Nuclear Regulatory Commission
Washington D.

July 12, 2010

Re: Florida Power and Light, Turkey Point, Units 6 and 7

Attachment Slide 2

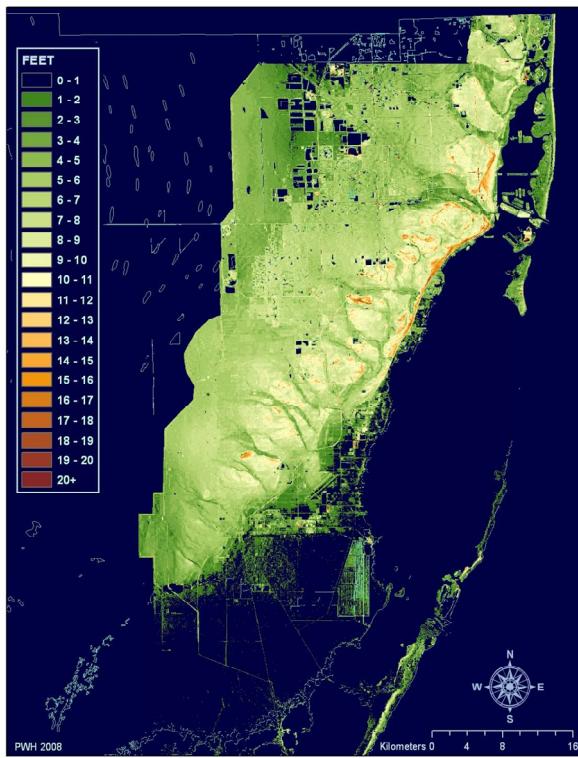
including the area around Turkey Point and the access road to the facility.⁶ A two foot rise covers 28% of Miami Dade County's land mass. Turkey Point generating facility effectively becomes an island. The current cooling canals for the existing nuclear generating facility become unusable as they are breached by rising bay waters.⁷

Attachment Slide 6

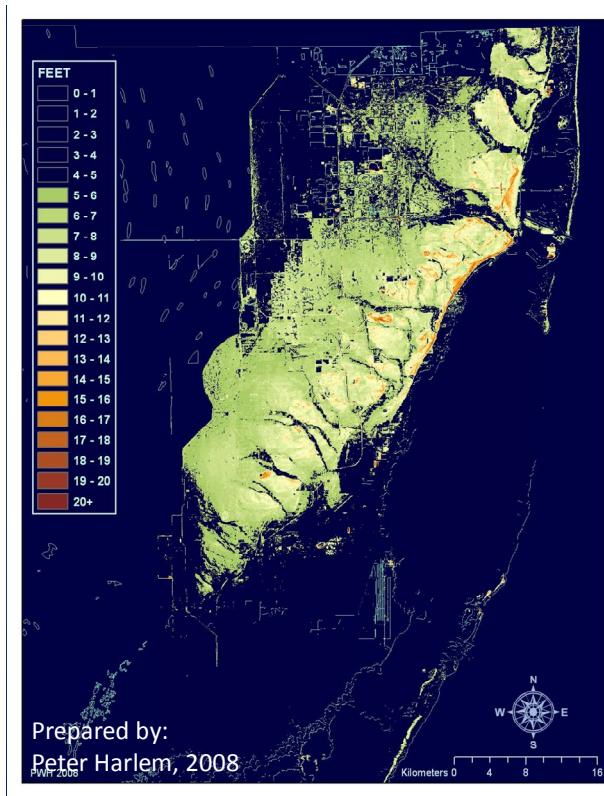
At the full predicted 5 foot range of sea level rise, occurring sometime between 2070 and the turn of the century, only 54% of Miami Dade County remains high and dry. FPL's proposed power lines running down the western side of the County's Urban Development Boundary (UDB) are miles from dry land as that part of the Everglades is flooded with both fresh water, used to hold back the rising sea, and salt water which is fast encroaching. The coastal ridge is now divided by tidal channels into a series of independent islands displacing a million or more county residents. The effect of any hurricane storm surge will force an additional million or more residents to leave the county for higher ground as they have already had to do on the barrier islands of Miami Beach and Key Biscayne.⁸
